California Energy Commission Staff
Workshop for the 2010-2011
Alternative Fuels Investment Plan
September 14-15, 2009

SWAN Biomass Company
Initial Comments

DOCKET	
09-ALT-1	
DATE	_____
RECD.	<u>9/23/2009</u>

Renewable Fuels Required to Meet California RFP2 Mandates--CEC Projection 9/2009

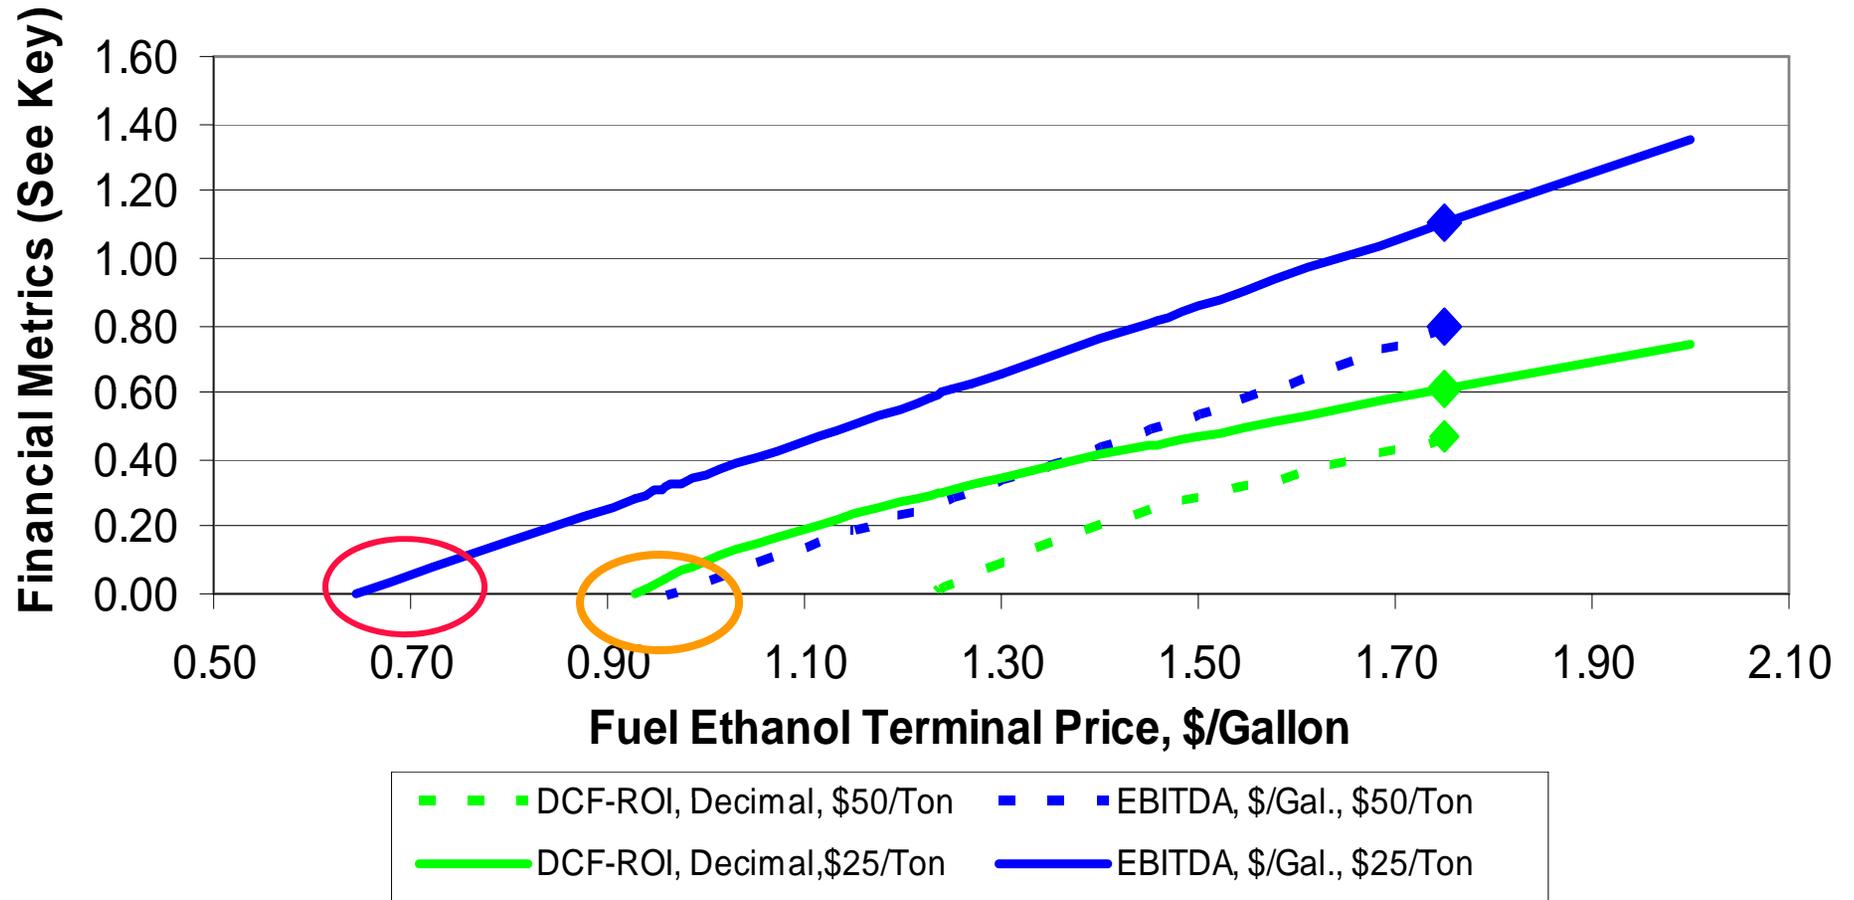
Preliminary Conclusions

- The supply of/demand for starch based fuel ethanol is expected to weaken beginning in 2015
- Cellulosic ethanol is expected to begin to grow in 2010 based on “fair share” principles reaching 1,345 million gallons by 2022
- This growth could be accommodated by 13-14 Biorefineries each with 100MM GPY, a reasonable objective in a 12 year time frame.
- The launching of a SWAN Biorefinery may alter these forecasts.

Renewable Fuels Required to Meet California RFP2 Mandates--SWAN Projection 9/2009

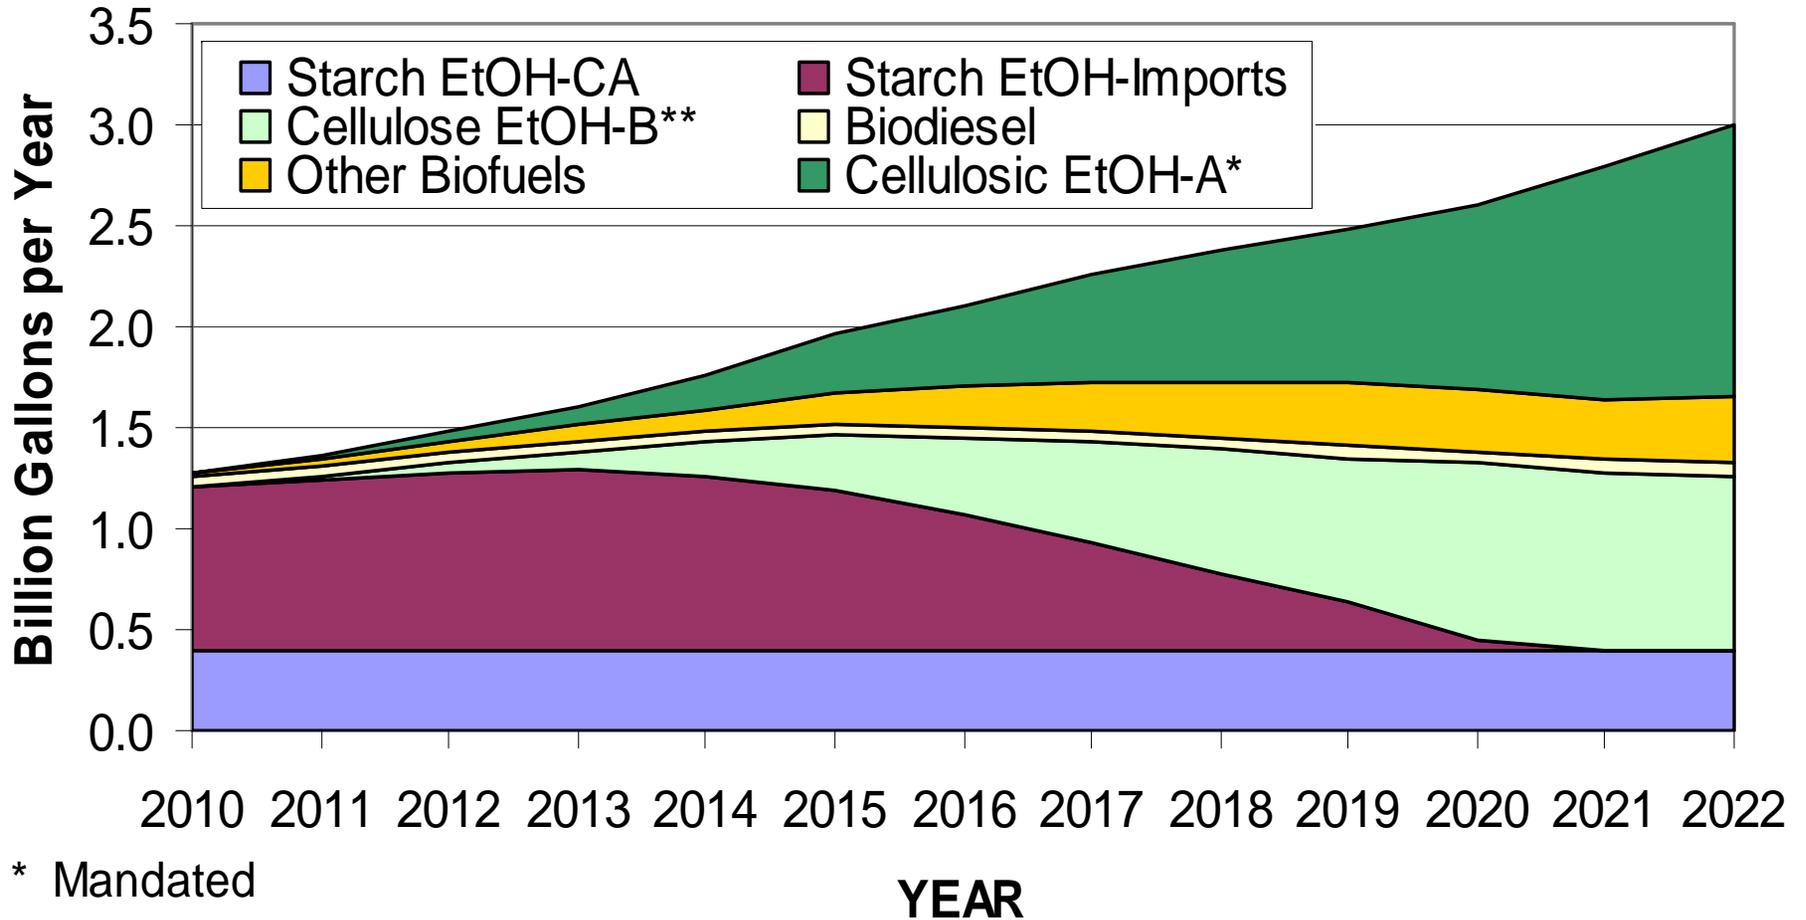
Cellulose Process Economics Can be a Competitive Advantage

- The production of ethanol from cellulosic feedstocks may grow from the projected 1,345 MMGPY to about 2,206 MMGPY million gallons per year, requiring a total of about 22-24 facilities with 100 MMGPY capacity.
- The private sector will not need help (or a mandate) under this scenario—pursuit of profit can be the driving force.
- The increase can be handled easily by the construction strategy being used so long as it is initiated quickly.
- California has an opportunity to extend its ethanol capacity to meet those demands, or to cede that which it does not fill to low cost ethanol imported from domestic or foreign sources. If the challenge is met it can result in a substantial number of new jobs or saved old jobs.
